**Accessibility Survey**

## City of Downey Brookmill Road - Old River School Road To End

Date of Inspection 4/19/2017

**Disability Access Consultants**

#### Change In Level East Of Samoline Avenue @ 33.938241985297, -118.141845613718

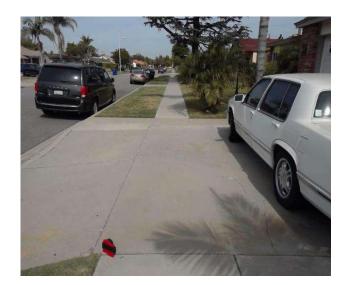
There is a change in elevation greater than recommended value.

**On-Site Finding** 0.50 inches

Ensure that the change in elevation is within the recommended value.

Recommendation Up to 0.25 inches

## Southeast Corner Of Morning Avenue @ 33.939070893384, - 118.143609166145

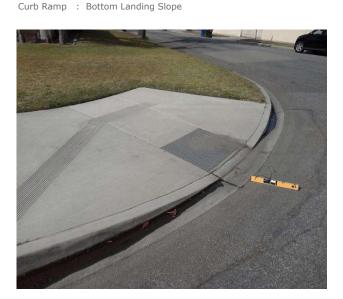
The bottom landing of the curb ramp is on the street, and the slope of the bottom landing is not compliant.

**On-Site Finding** 14.10 percent

Ensure the bottom landing slope is compliant and provides a smooth transition.

Recommendation Up to 5.00 percent

# Sidewalk East Of Rives Avenue @ 33.939522617079, -118.143976628780

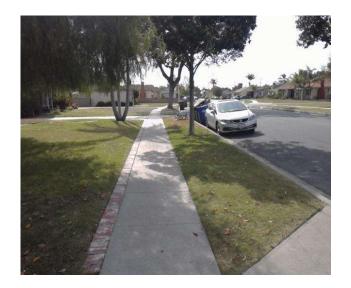
Sidewalk cross slope is not compliant.

**On-Site Finding** 3.60 percent for 21.00 feet

Repave the sidewalk surface with the recommended cross slope.

Recommendation Up to 2.08 percent
